A. General

107-16156

Layout fuel pump assembly

- 86 Fuel filter with damper
- 87 Fuel pump
- 95 Diaphragm damper

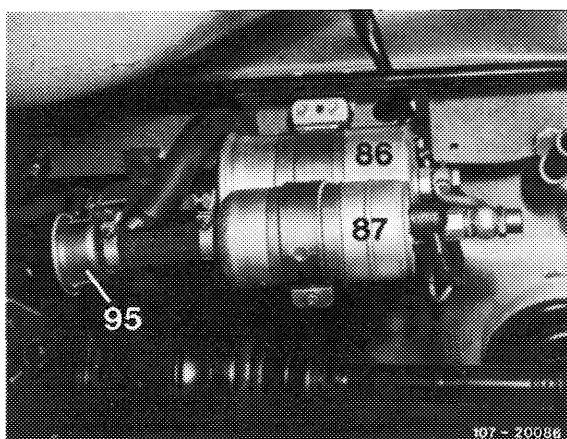
On models 107 and 126 fuel filters will be installed with damper (86), as well as a diaphragm damper (95). This will reduce noises caused by fuel pump.

On vehicles in national version (AUS) (J) (S) and (USA) with CIS injection system prior to model year 1981, the respective components can also be installed. On vehicles of model year 1981, the changes are already in place. However, the fuel pump assembly differs by a fuel filter of larger diameter (owing to revised maintenance intervals).

On vehicles with lower chassis end no. the components can be subsequently installed in the event of complaints about "Fuel pump loud".

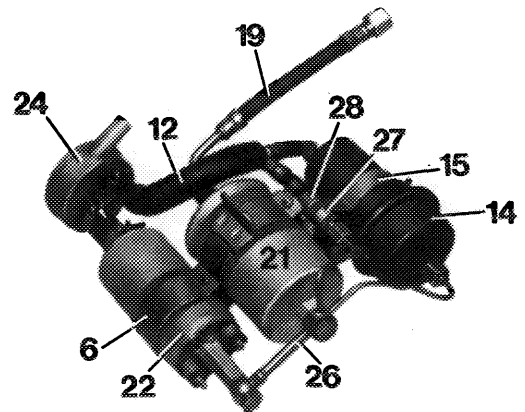
When exchanging fuel filter (21), fuel pump (22) or pressure compensating valve (27) make sure that a plastic sheet or plastic sleeve is mounted between these parts and holder (6, 15, 28). Sleeve should project on both sides of holder, since direct contact of parts with holder may lead to contact corrosion.

On vehicles in (AUS) and (J) version, a pressure compensating valve may not be subsequently installed.

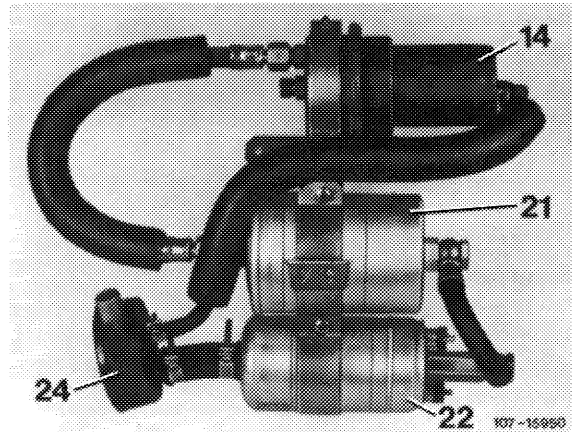
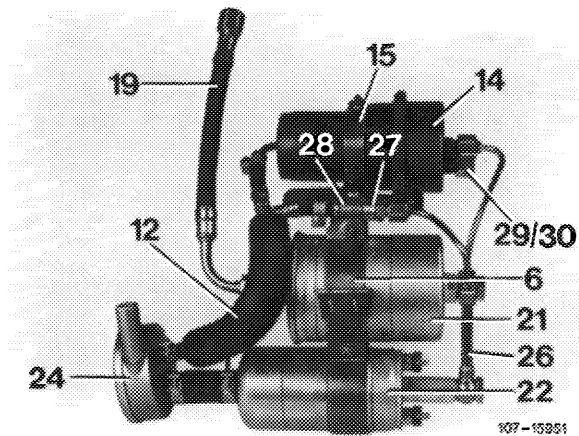
Since February 1979 the pressure reservoir (14) is connected in front of fuel filter, and an additional pressure compensating valve (27) is also installed. As a result, the cold engine will fire much easier and smooth running directly following a cold start will be improved.

The pressure reservoir (14) has now only one connection and owing to a throttle is filled only slowly with fuel. From fuel filter the fuel flows directly into feed line toward engine. As a result, the fuel pressure is building up much faster at injection valves.

In front of fuel filter (21) is an additional pressure compensating valve (27), which closes in the event of pressure in system. If the fuel volume in system is reduced when the fuel is cooling down, the pressure compensating valve will open. This will prevent that the control piston in fuel distributor will be pulled to full load under influence of vacuum, since otherwise during a cold start the full fuel quantity might be injected for a short period and the engine might be excessively enriched.

- 9 Assemble with components of conversion kit pump assembly, as shown in illustration. Slip fuel pump (22) up to bead into holder (6) and mount clamp (28) for pressure compensating valve (27) under holder of pressure reservoir. Prior to tightening screws of holder, position fuel pressure line (26) at pump, filter and pressure reservoir, align parts in relation to each other and tighten screws. On pressure reservoir, close the off-center connection with a closing cone (29) and a coupling nut (30).
